Re: Petition of KCE CT 8, LLC for a Declaratory Ruling that no Certificate of Environmental Compatibility and Public Need is Required for the Proposed Construction, Operation and Maintenance of a 4.9-megawatt (“MW”) Battery Energy Storage System, to be Located at 44 Skinner Street, East Hampton, Connecticut

**STATE OF CONNECTICUT
CONNECTICUT SITING COUNCIL**

Petition No. 1581

Petitioner KCE CT 8, LLC (“KCE”) hereby submits the following responses to the Interrogatories that were directed to KCE by the Connecticut Siting Council (“CSC” or “Council”) on July 21, 2023.

(Revised Figure 4)

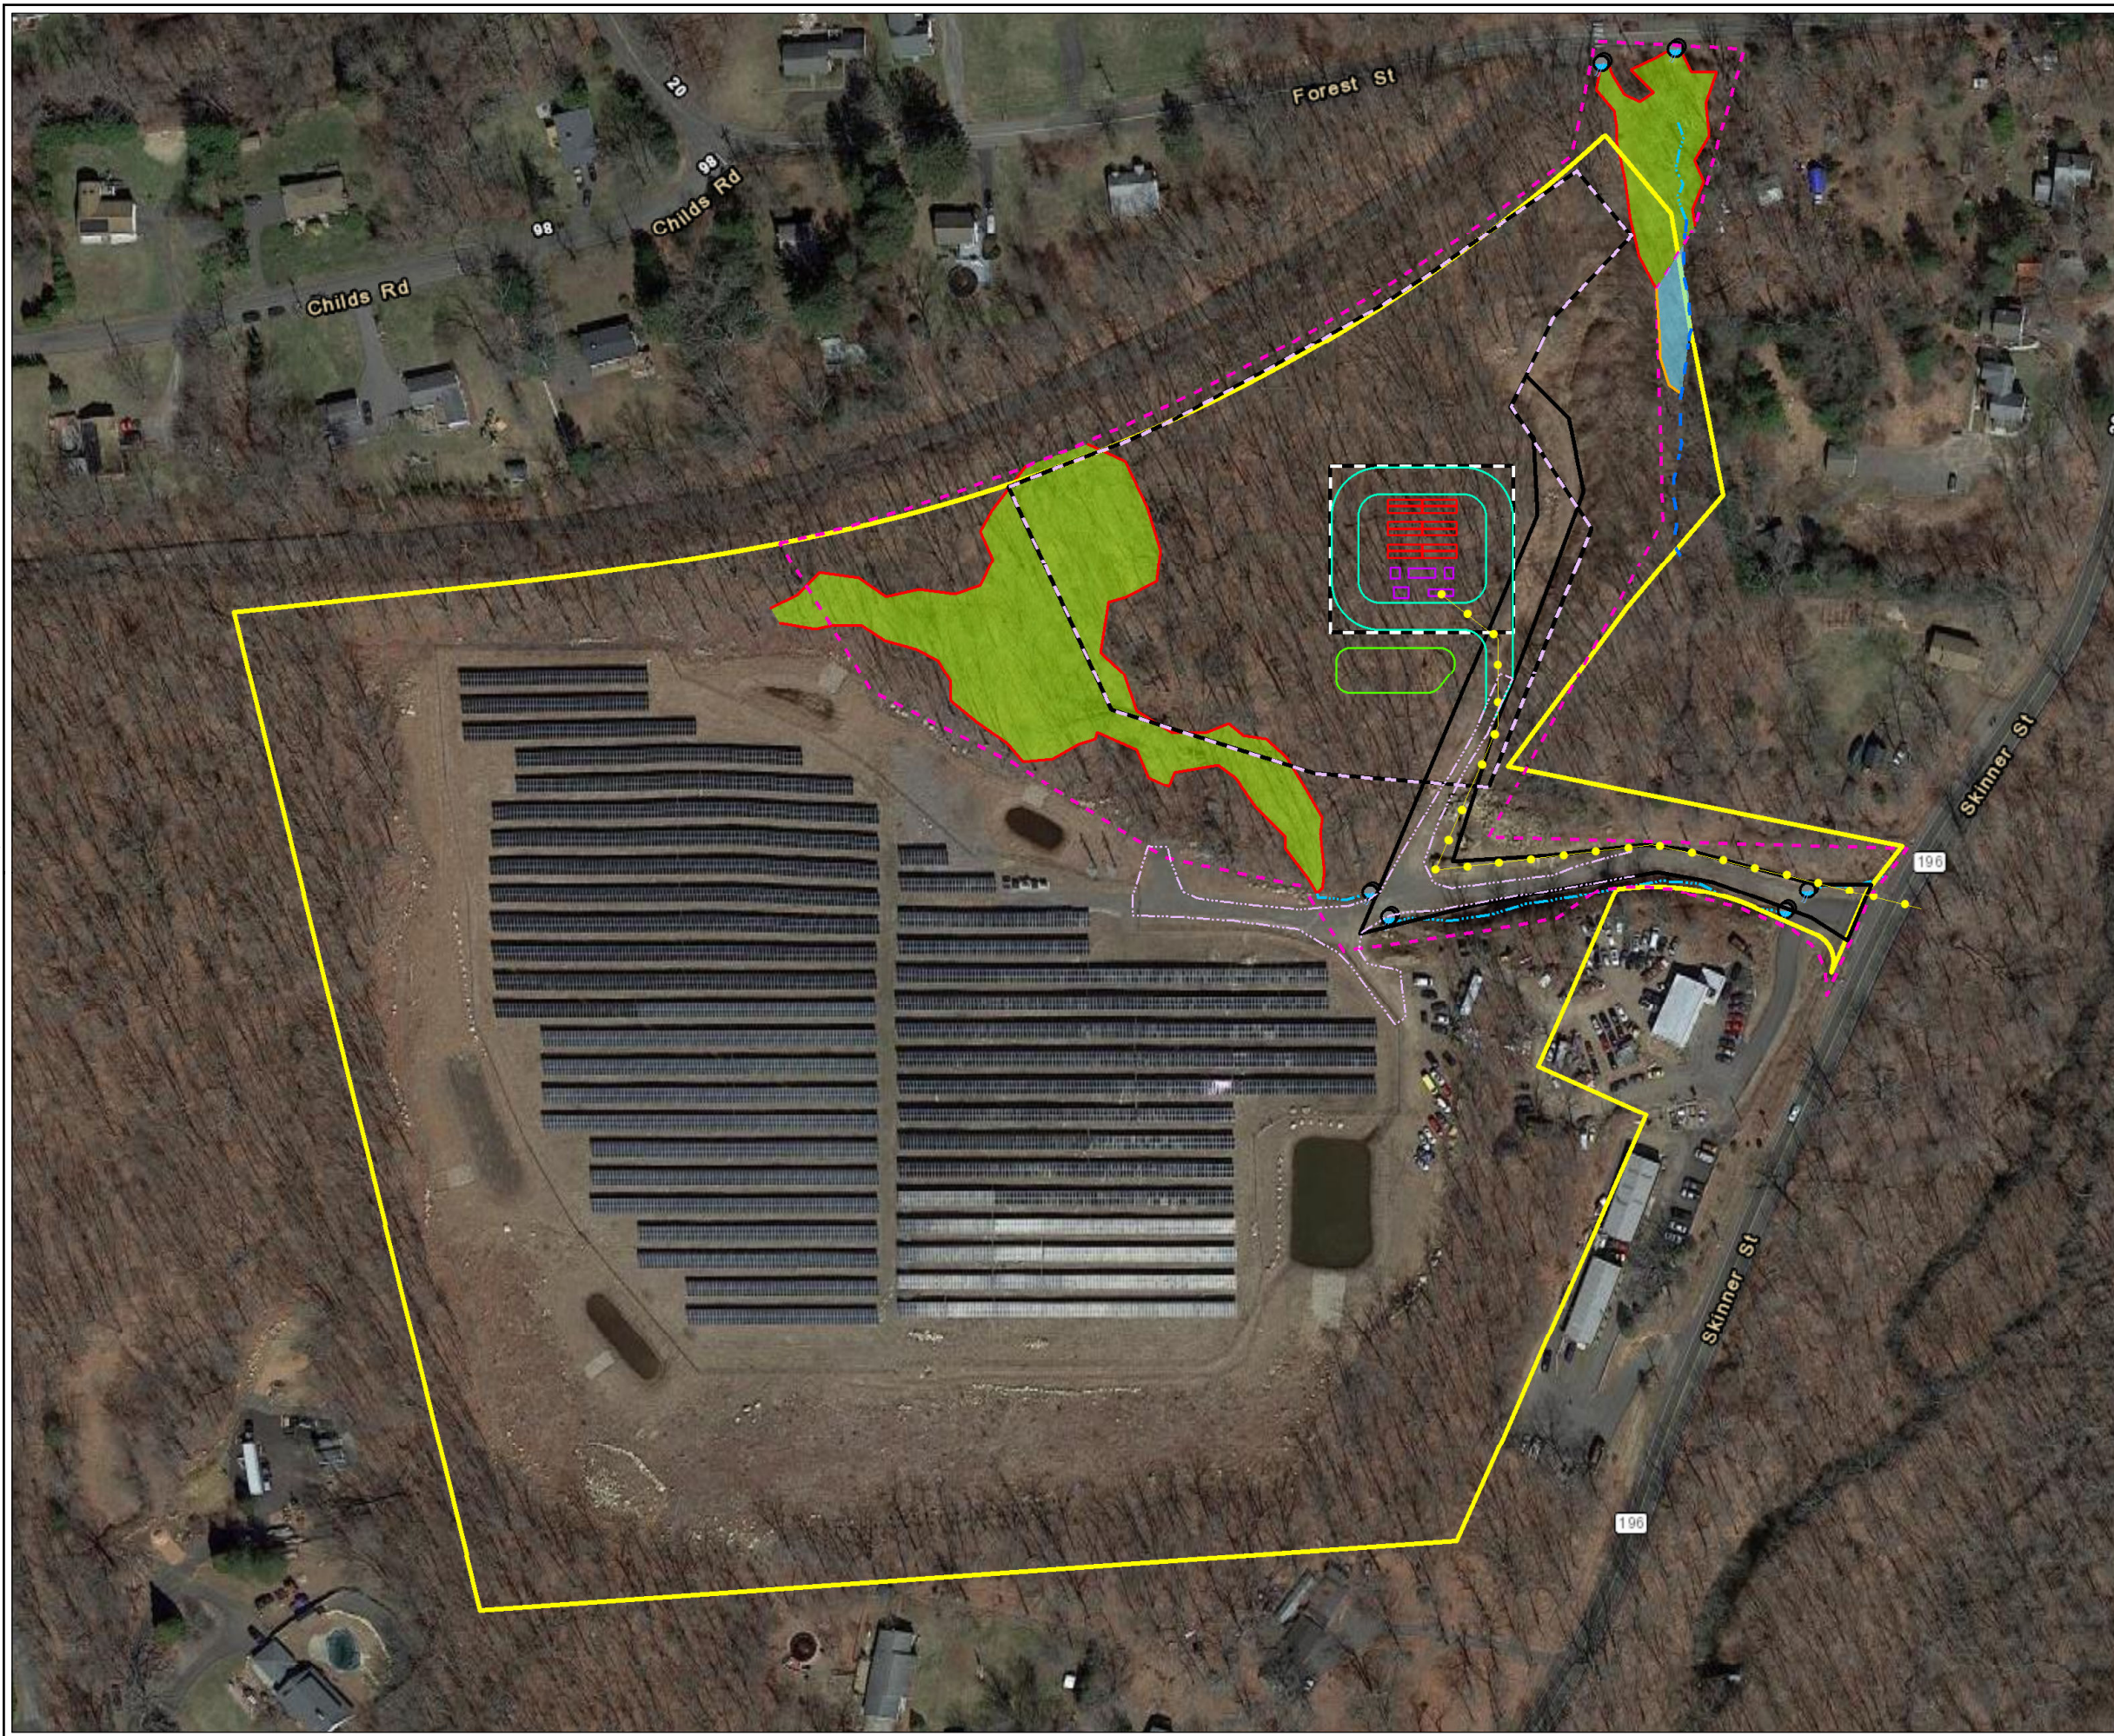
- 7. Submit a map clearly depicting the boundaries of the battery energy storage facility site and the boundaries of the host parcel(s). Under Regulations of Connecticut State Agencies (RCSA) §16-50j-2a(29), “Site” means a contiguous parcel of property with specified boundaries, including, but not limited to, the leased area, right-of-way, access and easements on which a facility and associated equipment is located, shall be located or is proposed to be located.**

A lease map, attached hereto as **Exhibit A**, shows the project lease development area, and pursuant to the terms of the lease agreement, all property not included within the designated area is excluded from development by KCE.

Not Approved for Construction
Drawing Title: **Layout and Materials Plan**

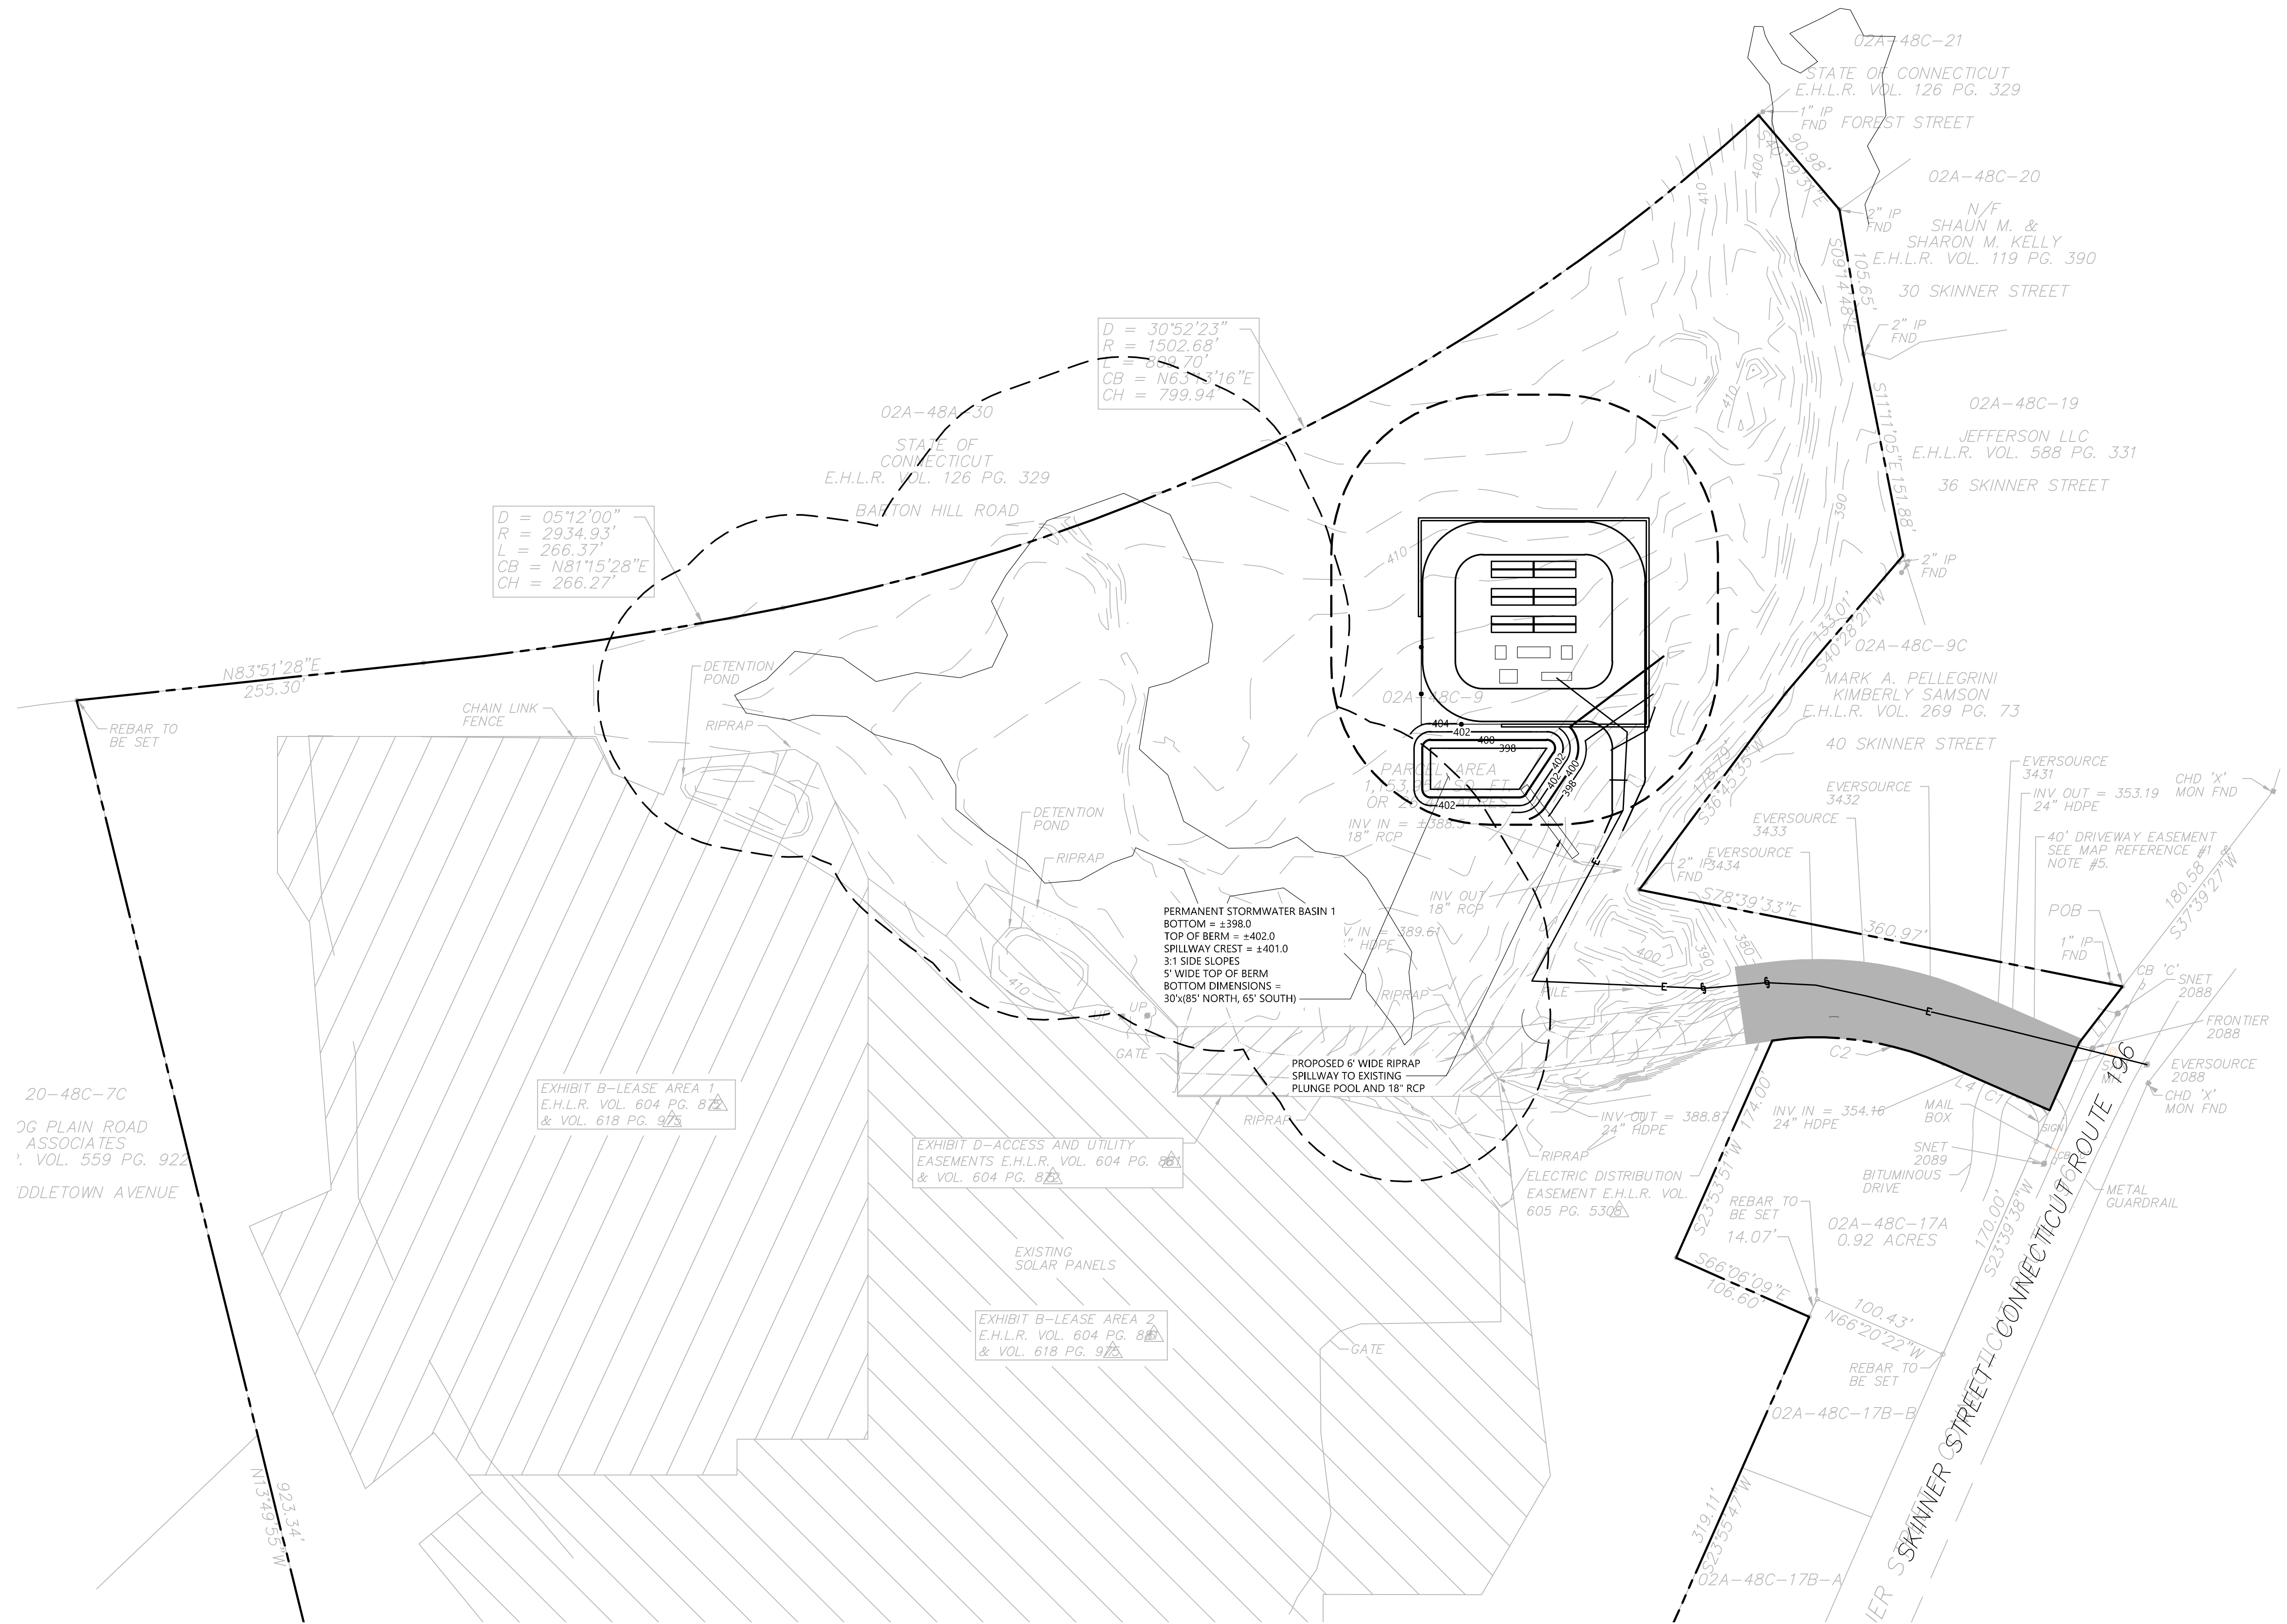
26. Referencing Petition Exhibit A – Sheet C-2.0, identify where within the compound the control house would be located.

27. Referencing Petition Exhibit A – Sheet C-2.0, list the equipment that would be installed on each equipment pad.

KCE currently intends to locate the control house at the southeastern corner of the project facility. Site Plan Sheet C 2.0 has been revised to depict this (attached hereto as **Exhibit C**).

Site Plan Sheet C 2.0 (attached hereto as **Exhibit C**) has been revised to depict the equipment currently expected to be installed on each equipment pad.
